**CITY OF CRESCENT CITY**  
**ADDENDUM NO.1**  
FOR  
**BEACHFRONT PARK IMPROVEMENTS**  
**PHASE 1B**  
**April 8, 2026**

**Beachfront Park Phase 1B – Changes are in narrative form only to the electrical drawings as listed below, items 1 - 5.**

Beachfront Park Phase 1B  
Addenda #1  
Soil Borrow Site - Exhibit A

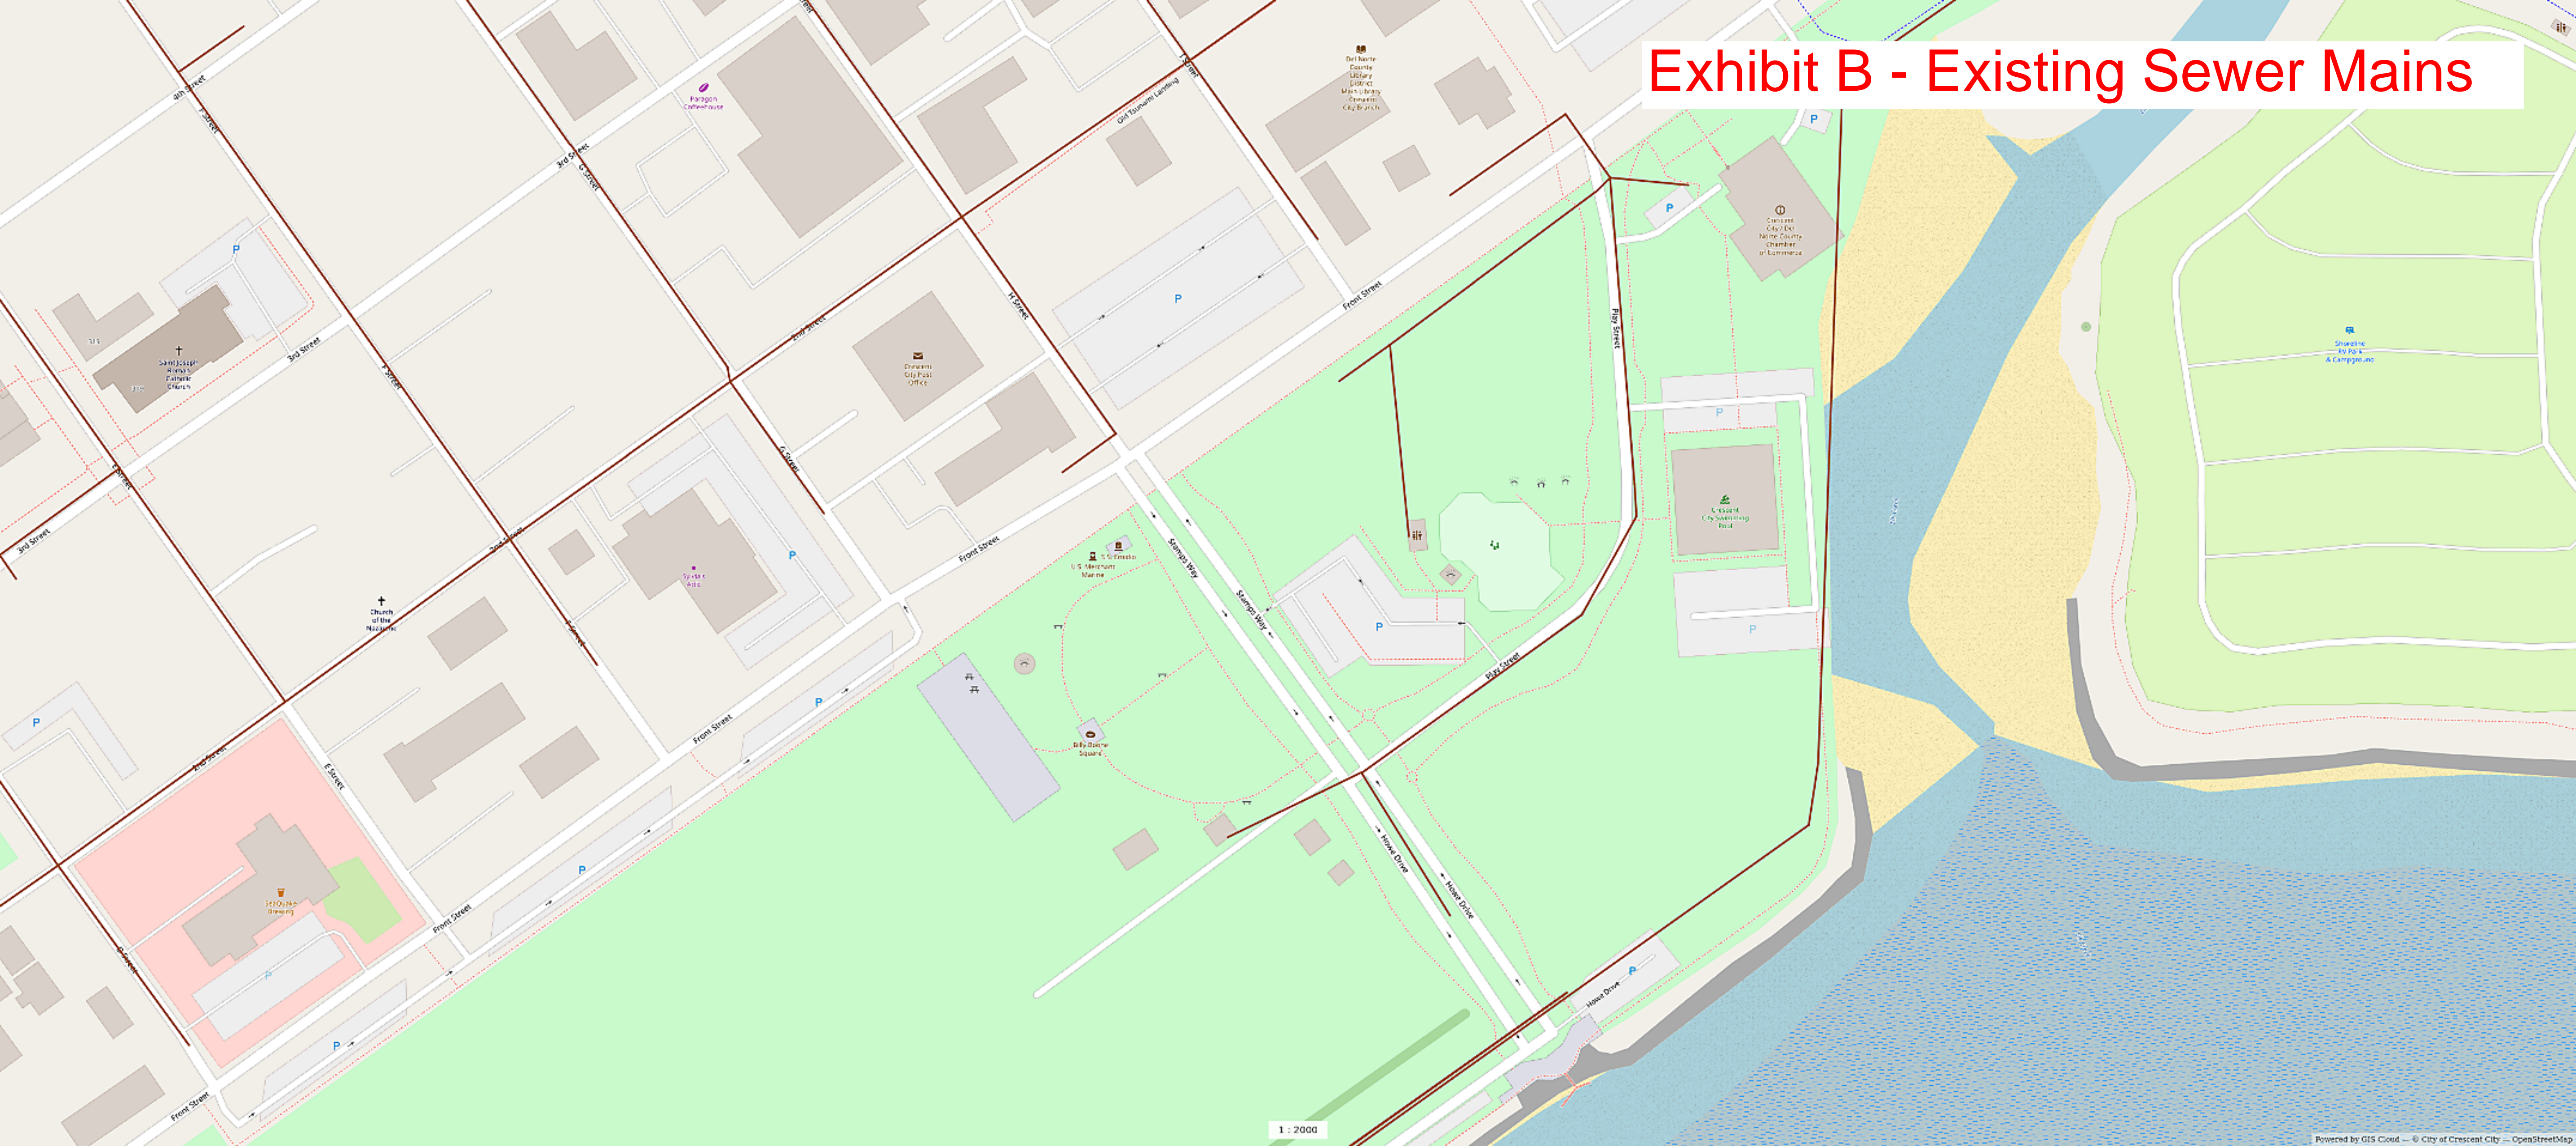
Exhibit A – Import borrow site map at Harbor Dredge ponds. This material is available free of charge to the contractor under a Harbor acquired permit. The contractor is required to load and haul the material.
